# MIAMI BEACH

### Design Review Board

SUBJECT: DRB20-0558  
**1161 Stillwater Drive**

An application has been filed requesting Design Review Approval for the construction of a new elevated one-story single-family residence including an understory area on a vacant site.

Final Submittal rendering

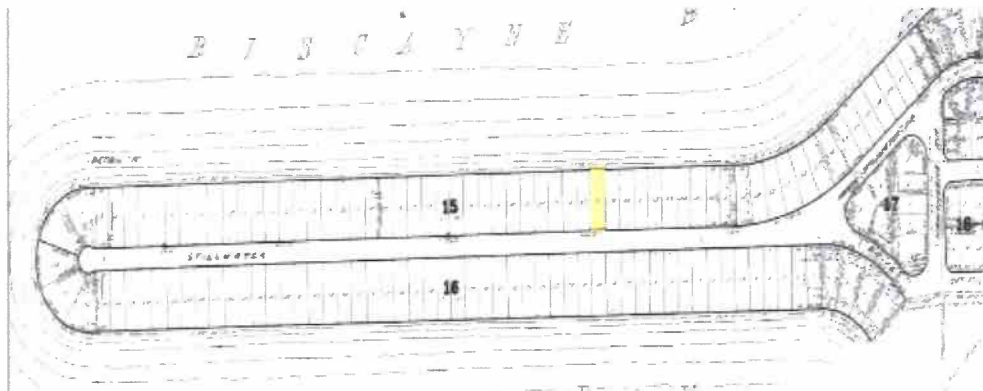
**Not Satisfied; the applicant is requesting review of the understory area. Front Rendering: IPE wood façade treatment should wrap both sides of volume of bathroom. Explore further articulation of understory on front elevation – grounding home to earth.**

- a. Exterior material selection should coordinate with architecture of the building, the IPE wood façade treatment as depicted in the 'Front Rendering' (DRB0.0) should wrap both sides of volume of bathroom.
- b. Explore further articulation of understory on front elevation – grounding home to earth.
- c. Ensure vestibule is no greater than 225 SF (3% of lot area).
- d. Explore greater changes in vertical plane from architectural framing to add depth.
- e. The front fence should be consistent in the orientation of pickets.

- b. The exterior material selection should coordinate with architecture of the building, the IPE wood façade treatment as depicted in the 'Front Rendering' (DRB0.0) shall wrap both sides of volume of bathroom.

- c. The architect shall explore further articulation of understory on the front elevation – grounding home to earth, in a manner to be reviewed and approved by staff consistent with the Design Review Criteria and/or the directions from the Board.
